AMENDMENTS TO THE DRAWINGS

REMARKS/ARGUMENTS

Fig 1

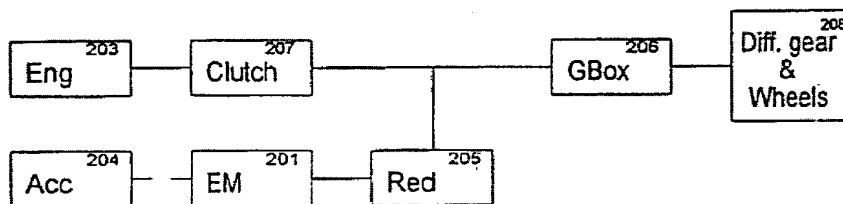
The attached sheets of drawings include changes to Figs. 1-3b and 6. These sheets, replace the original sheets for Figs. 1-3b and 6. In Figs 1-3b, the label "CONVENTIONAL ART" has been added. In Fig. 6, duplicate references have been eliminated. Attached are both replacement sheets and annotated sheets showing the drawing changes.

CONVENTIONAL ART

Fig 2

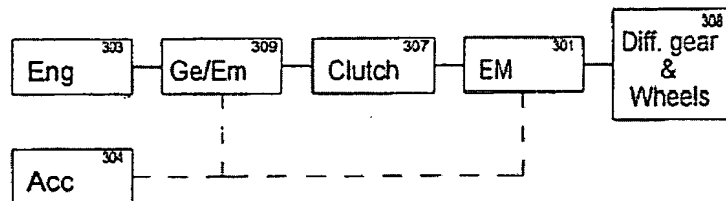
CONVENTIONAL ART

Fig 3a

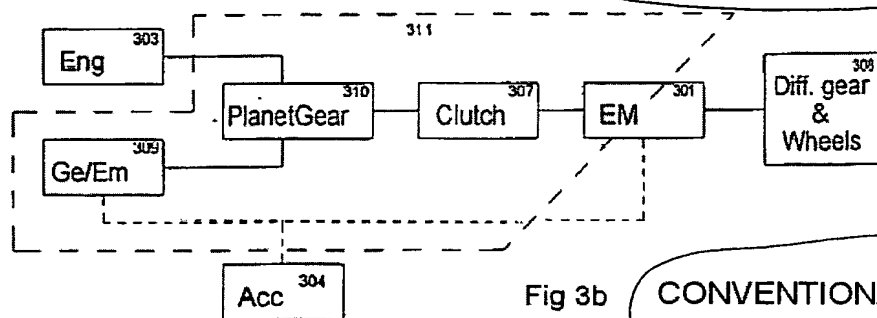
CONVENTIONAL ART

Fig 3b

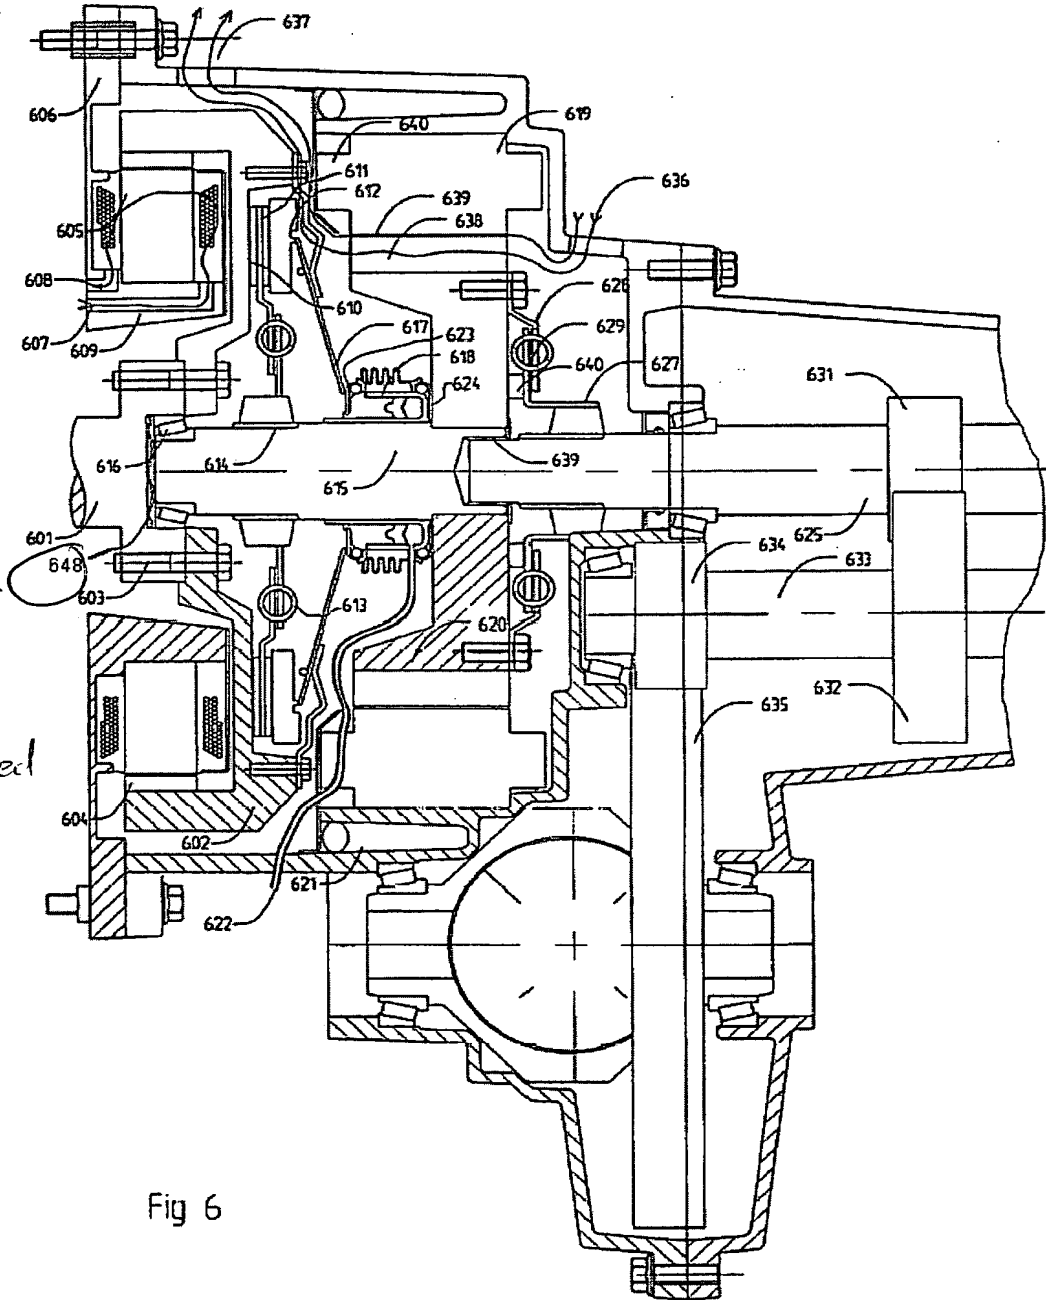
CONVENTIONAL ART

Label Added
